Appendices

DOI and EPA Misled About Undated Attachment D Figure

DOI Falsely Asserted that EPA Was Trying to Dig High when it Actually Excavated Below Assumed Water Level

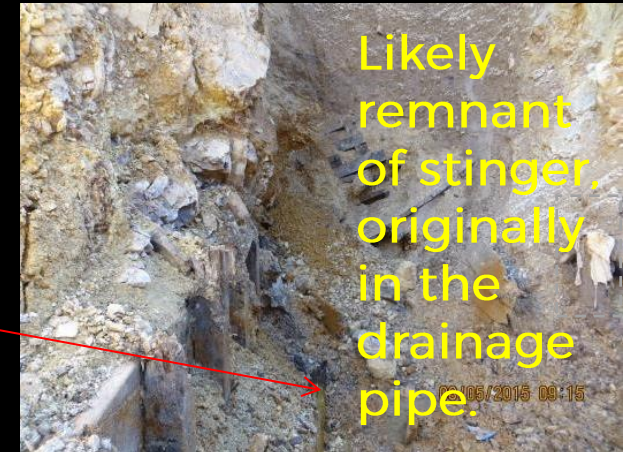
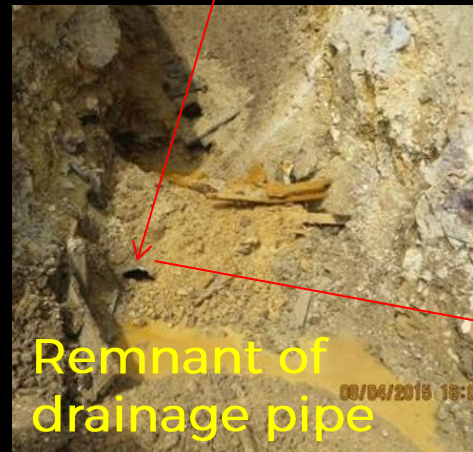
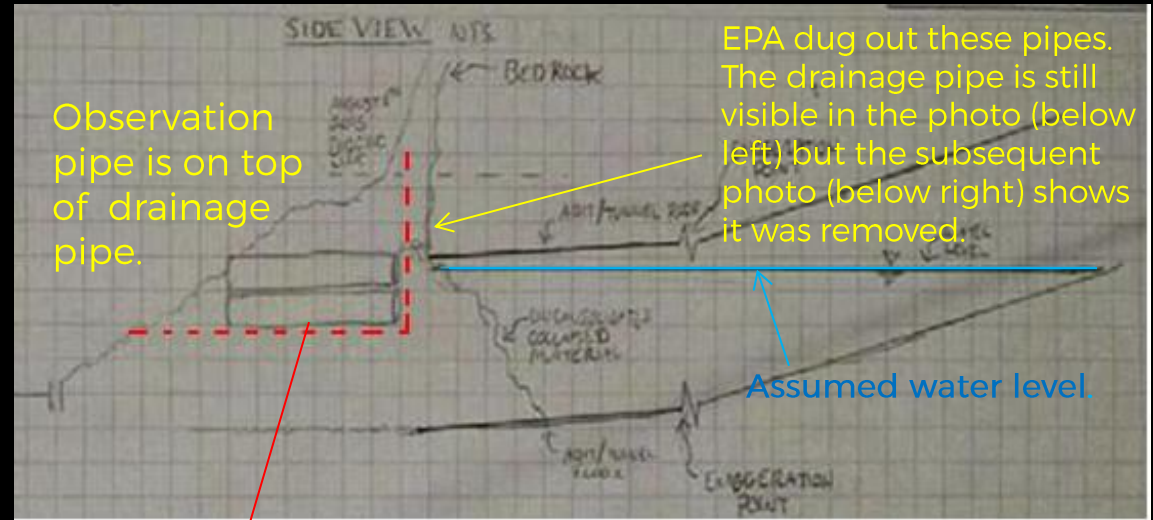
EPA's Attachment D indicates that EPA knowingly excavated close to the plug, and, in doing so, was at an elevation below the water level that they reportedly assumed in the drawing.¹ The pipes (and dashed red lines) were actually lower relative to the floor as shown in figures A 17, 18, and 19. This means that EPA actually was digging even lower than their assumed water level.

DOI's *Technical Evaluation* includes a photo showing a partially *backfilled* excavation (See, A 4) and its caption misleadingly states, "[t]his indicates that the bottom of the excavation was about 10 feet above the level of the floor of the adit; this corroborates reports that they were *digging high*, trying to stay above the assumed water level in the adit. . . ."² DOI failed to mention that this statement relates to the elevation after EPA backfilled and relies on the idea the drainage pipe was substantially above the floor.

Depiction of "EPA's Plan" in DOI's Technical Evaluation

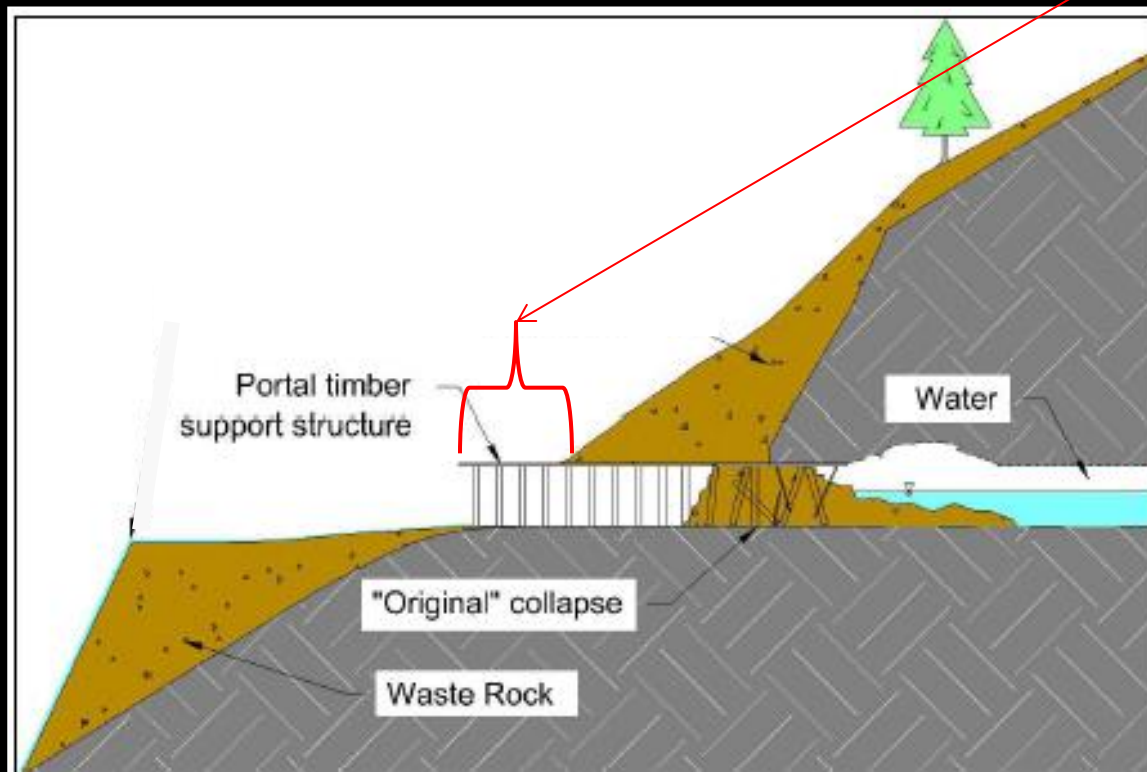
Although not shown in DOI's sequential figures, these pipes were removed by EPA.¹

Despite DOI's account, the Committee was advised by individuals present at the Gold King Mine on August 5th, 2015 that there was neither a stinger nor a pump on-site at the time of the blowout.²

DOI Wrong About Basic Technical Details of the Gold King Mine

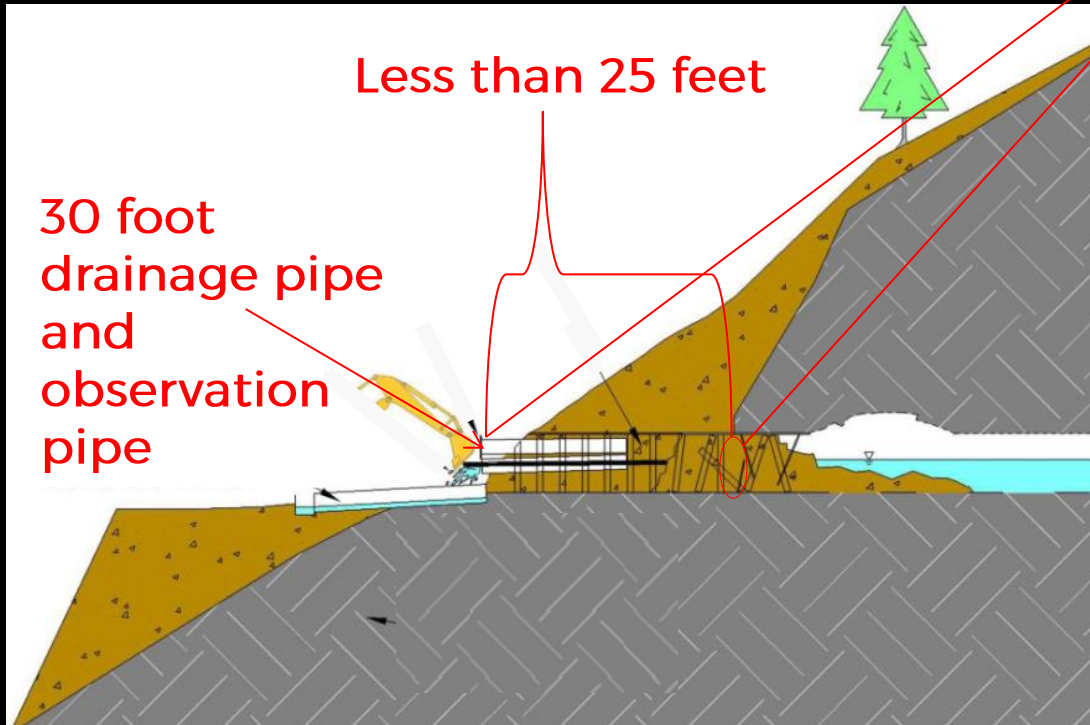
DOI's *Technical Evaluation* depicts the opening of the portal structure (below left) as extending four timber sets (two vertical timbers supporting a horizontal cap timber) beyond the slope of the mountainside. This is inaccurate, as evidenced by a 2004 DRMS photo (right) and a construction photo from 1984 (below right).¹

DOI Made Use of “Not to Scale”

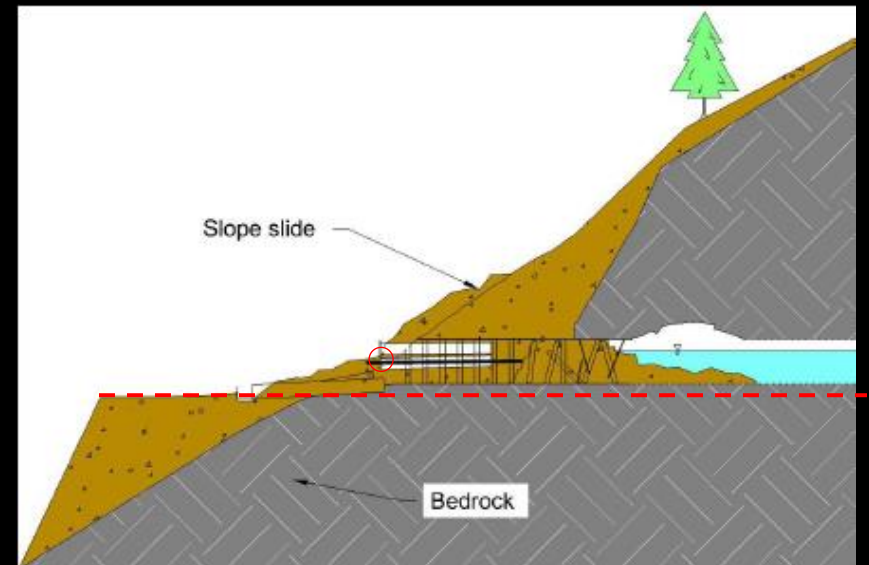
The enlarged portion of the figure in the *Technical Evaluation* (right) reveals that DOI was accurate in noting that the figure is “not to scale.”¹ It is not possible for a two foot diameter drainage pipe to rest at about the same elevation as the waste rock dump/adit floor (photo below)² and abut another two foot diameter pipe that is flush with a eight (or 10) foot roof.³ DOI’s not-to-scale figure makes the physically impossible scenario less obvious, and it obscures EPA’s error.

Above : Enlargement of below DOI figure showing distortion of distance between drainage pipe and waste rock dump.

DOI Scenario on Relative Elevation of Adit Floor and Mine Waste Dump

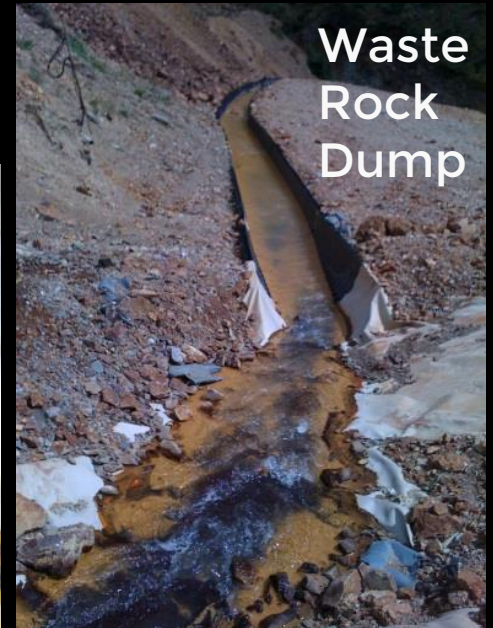
The DOI *Technical Review* is nonsensical. It avoided EPA’s assertion that the adit floor was lower than the waste rock dump. Instead, DOI repeatedly produced figures that showed the adit floor and waste rock dump at a similar elevation (see figures on A12 and A13 for example).

However, DOI also incorporated EPA’s assertion that the observation pipe abutted the roof of the portal structure, and that the drainage pipe was immediately beneath it.¹ For both of these assertions to be true, the drainage pipe would have to be elevated noticeably above the waste rock dump. This is not the case (see left). The dashed circles show the approximated locations of the 24” pipes, abutting an eight foot portal structure roof with a floor approximately level with the waste rock dump.² DOI explained that the water from the drainage pipe pooled because the excavation had a lip (inset).³ However, to make that scenario plausible water draining from the pipe would have required a huge “lip” that was almost level with the bottom of depicted drainage pipe elevation.

DOI *Technical Evaluation* depicts stinger installation.

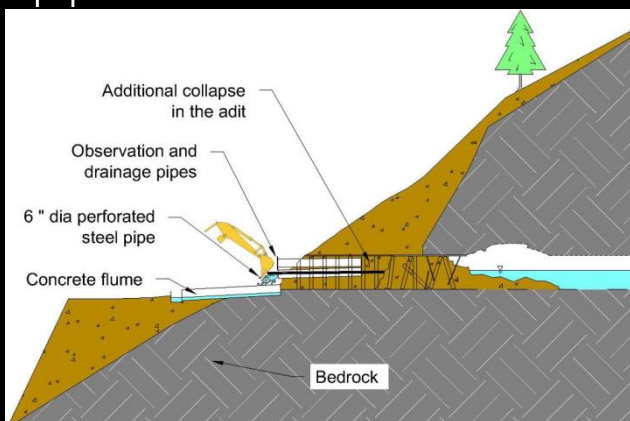
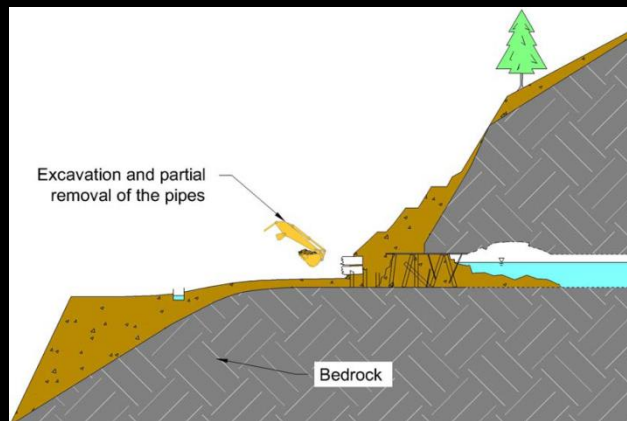
In the below left image, DOI shows the bottom drainage pipe discharging directly to the concrete flume.³ This also is incorrect. There was a pipe between the concrete flume and the discharge pipe.

The stinger is gone in the next image, but the *Technical Evaluation* does not mention its removal.

DOI Inaccurately Depicted Condition of Support Timbers Near Portal.

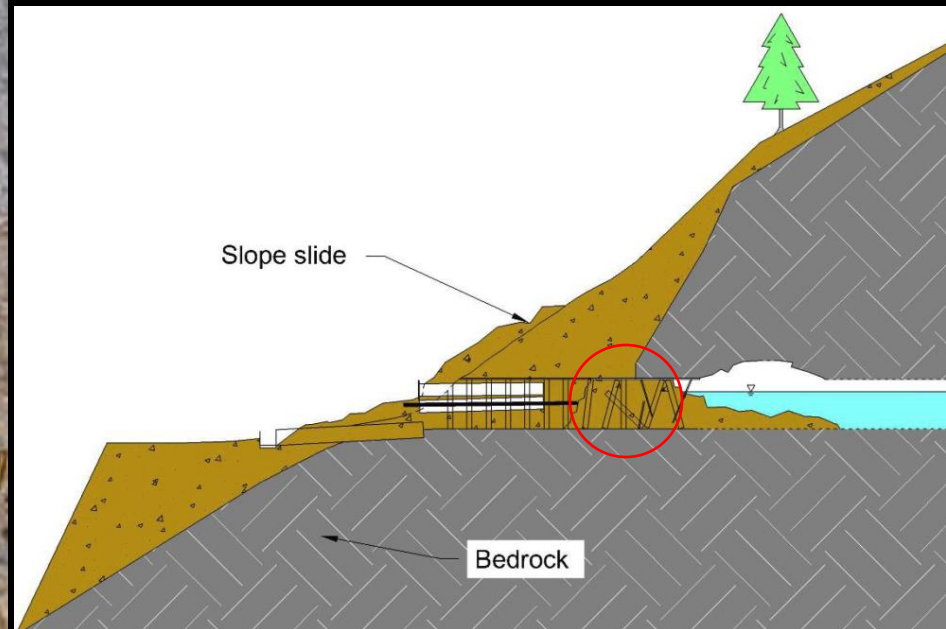
Lower right: DOI's *Technical Evaluation* consistently depicted the vertical timbers in the sets nearest the adit opening as collapsing.²
